TVA-SQN-TS-00-06

SEQUOYAH NUCLEAR PLANT (SQN) - UNITS 1 AND 2 - REVISION OF INSTRUMENTATION MEASUREMENT RANGE, BORON CONCENTRATION LIMITS, REACTOR CORE LIMITATIONS, AND SPENT FUEL POOL STORAGE REQUIREMENTS FOR TRITIUM PRODUCTION CORES (TPCs) - TECHNICAL SPECIFICATION (TS) CHANGE NO. 00-06

PROPOSED TECHNICAL SPECIFICATION (TS) CHANGE TS 00-06 AND TPBAR CONSOLIDATION ACTIVITY DESCRIPTION AND EVALUATION OF THE PROPOSED CHANGE

PROPOSED TECHNICAL SPECIFICATION (TS) CHANGE
MARKED PAGES

Fig. 5.6-6 Limiting Burnup Requirements in Region 4,
Checkerboard Array of 1 Fresh (with Gadolinia)
and 3 Type T Spent Fuel Assemblies

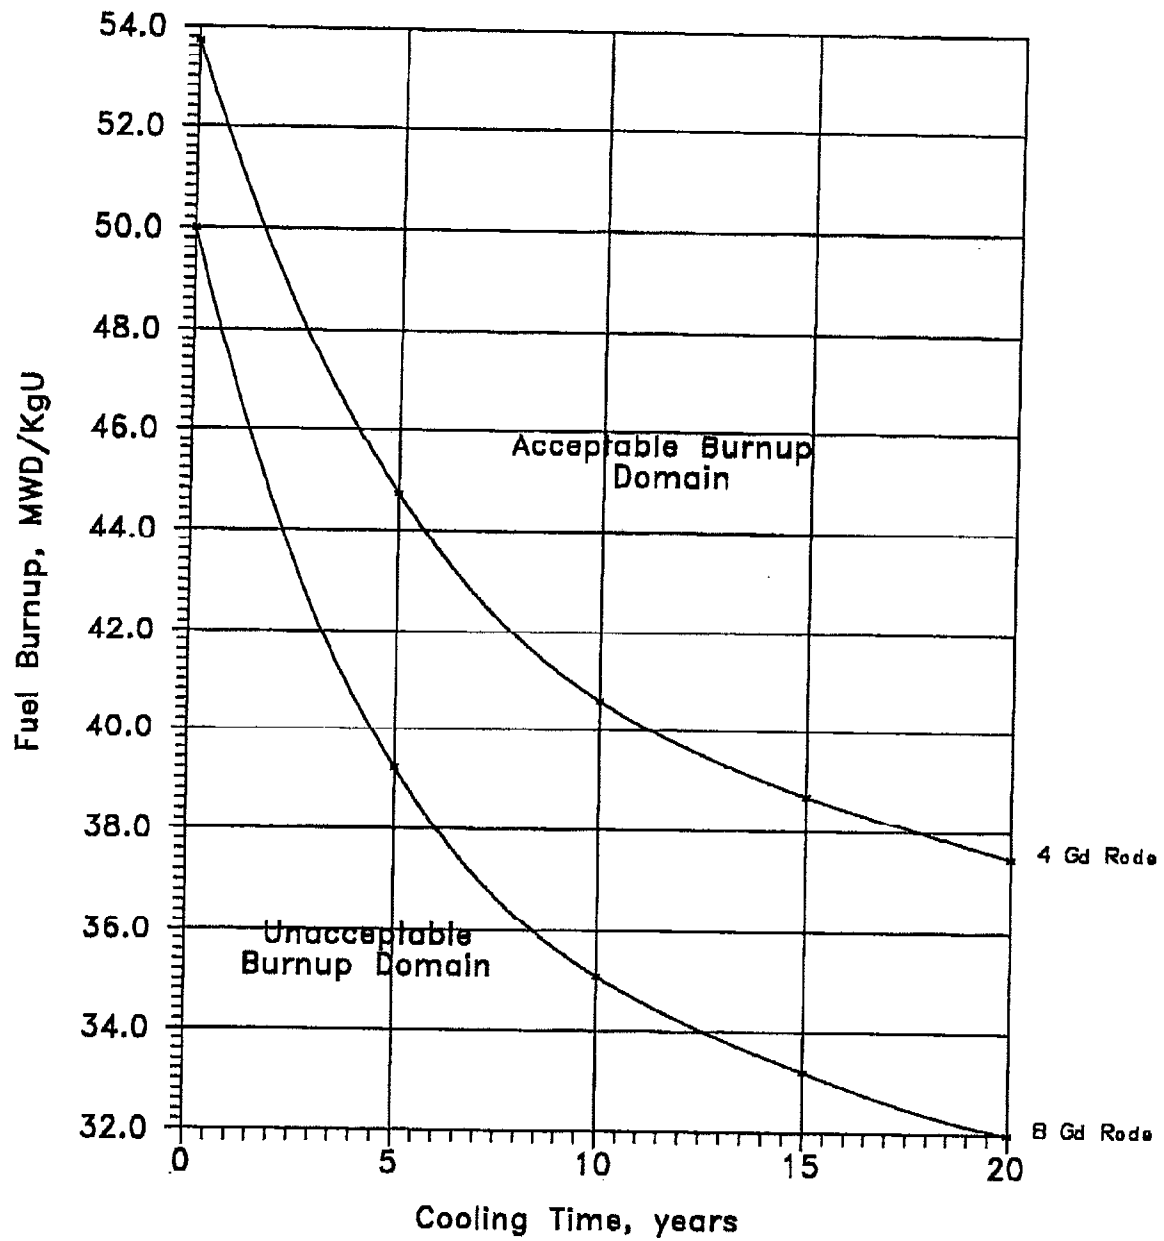
The figures and tables associated with Section 5.6.1.1 have been revised accordingly to properly represent the acceptable spent fuel storage patterns for each fuel type with appropriate enrichment, burnup, and cooling time requirements for storage in respective regions of the spent fuel pit. This change has revised the labels for the existing figures and tables to clarify their use for Type A spent fuel and has included other changes to reflect the new Type T spent fuel. New figures and tables for Type T spent fuel have been added with appropriate labels and information for controlling storage requirements for this fuel.

Insert 16
